Office Action Summary

10/718,086

CLEMENS, READE

DETAILED ACTION

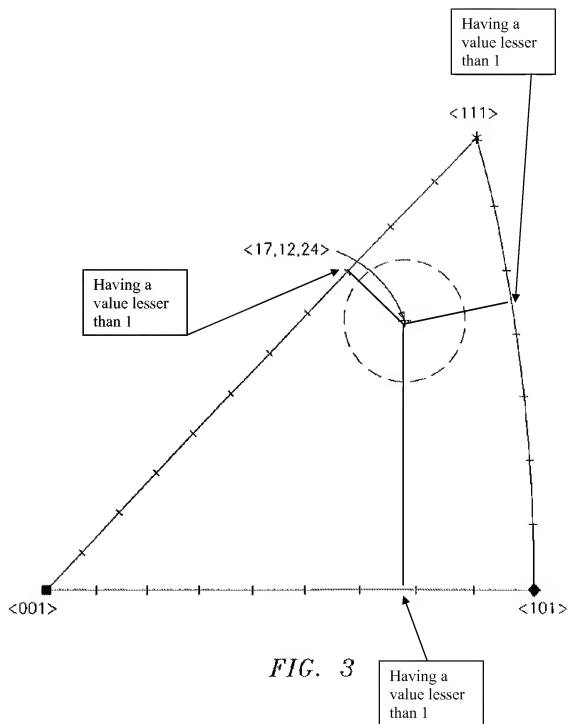
7. Claim 7 is rejected under 35 U.S.C. 103(a) as being unpatentable over Anderson.
- Anderson teaches the invention substantially as claimed but is silence on whether the diamond is synthetic or natural. However, choosing a synthetic diamond or a natural diamond to manufacture a diamond tip is not patentably distinct over prior art since it involves cost analysis, the availability of natural diamond and synthetic diamond and market demand.
